DESCRIPTIVE REPORT

Field No. PA-1157 Office No. H-8398

Locality Stuart Island - North Side

HYDROGRAPHIC SURVEY REVIEW

Section of Chart 6380
9th Ed Aug. 8, 1960
Data in red from H-8398

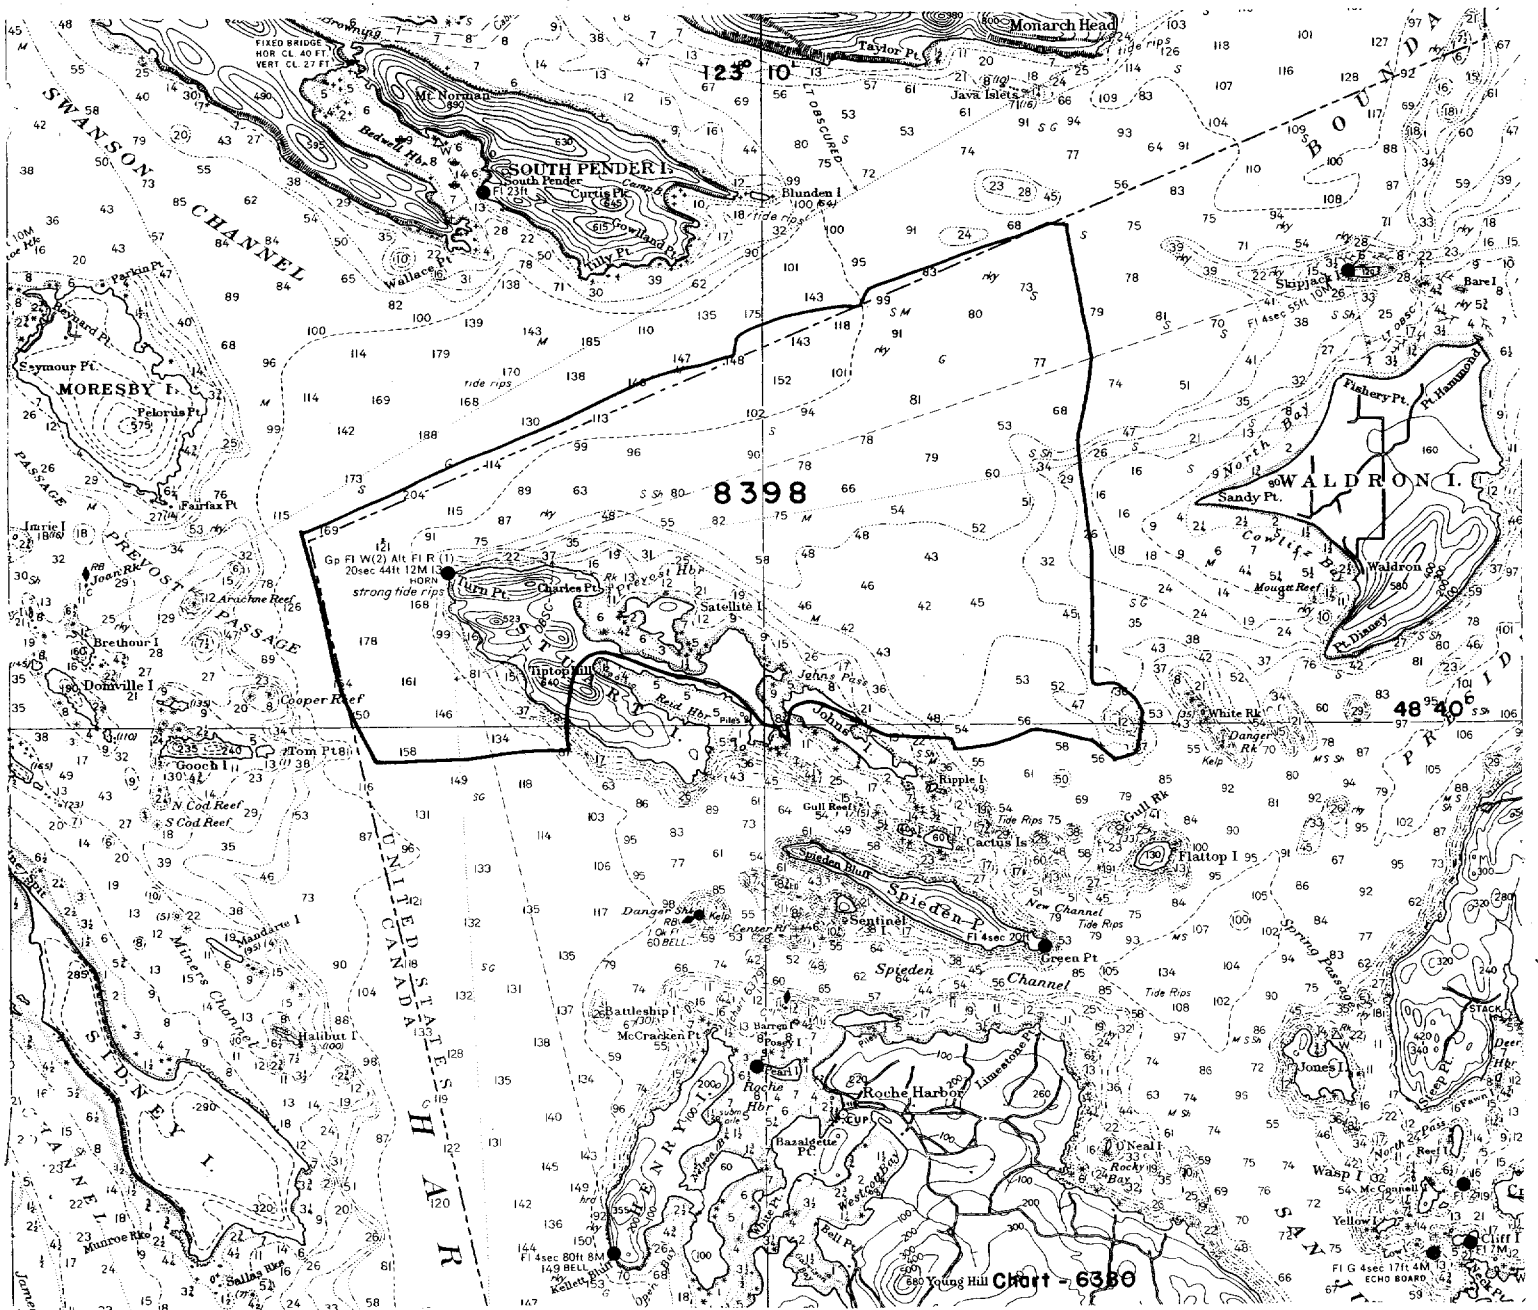
COMPARISON WITH CHART

This survey was compared with Chart 6380, 9th Ed., Aug. 9, 1960. All charted soundings in the area of the smooth sheet were checked and most were found in agreement.

See section of the above mentioned chart, attached to this report, for comparison.
